Mark Disosway, P.E.

Re: Gibraltar Contracting, LLC | Mouras Res. | 735 SW Sterling Terr., High Springs, FL

This letter is in reference to inspection issues on the above referenced project.

Truss Label: B19 repair

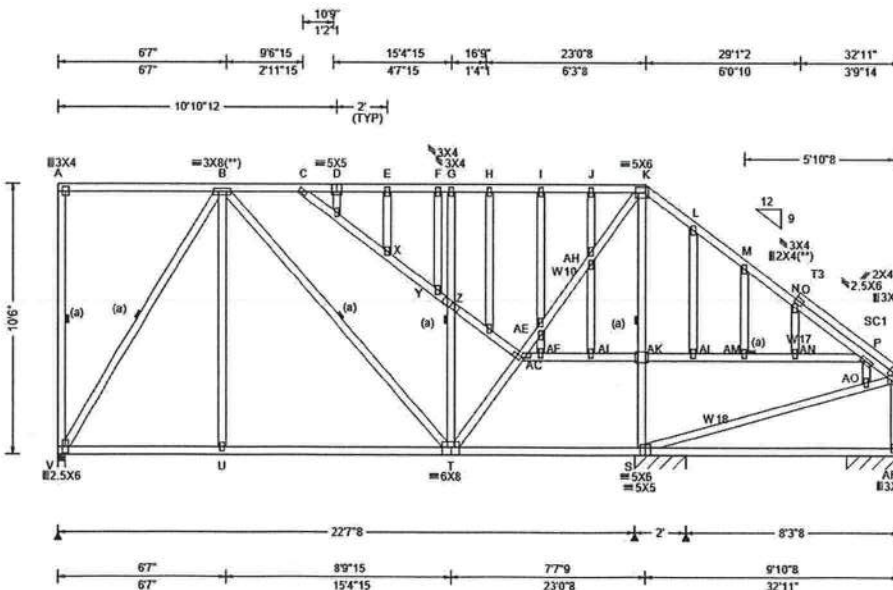
1. On the engineering we provided we called sheathing nailing for a (2) 2x6 header over the windows at the right side of the dining room. The builder would like to remove the header and only use (1) top plate. This is ok provided the conditions below are met.
 - a. The truss co. redesigned truss B19 to remove the bearing over the windows.
 - b. The single top plate must be continuous over the window.

Truss Label: B19 repair

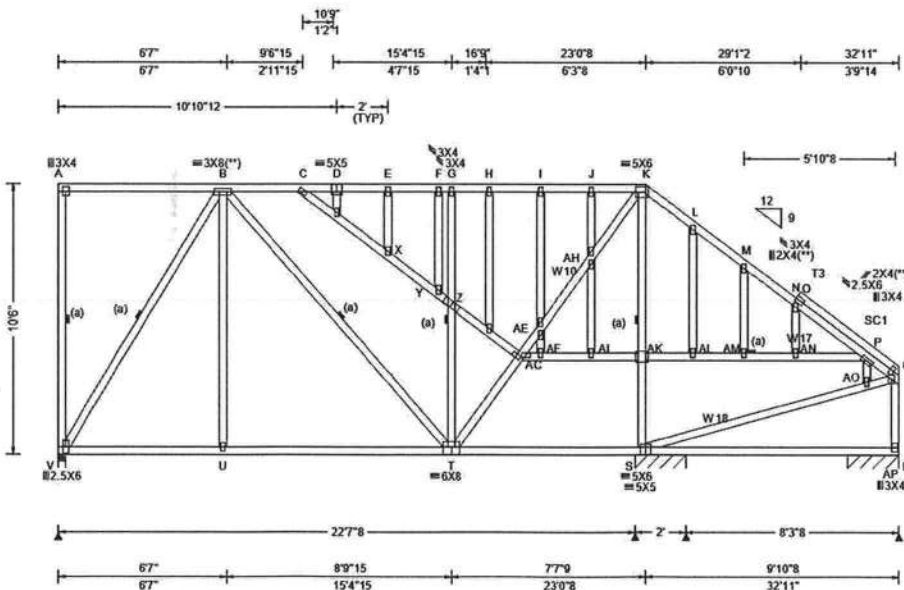
1. On the engineering we provided we called sheathing nailing for a (2) 2x6 header over the windows at the right side of the dining room. The builder would like to remove the header and only use (1) top plate. This is ok provided the conditions below are met.
 - a. The truss co. redesigned truss B19 to remove the bearing over the windows.
 - b. The single top plate must be continuous over the window.
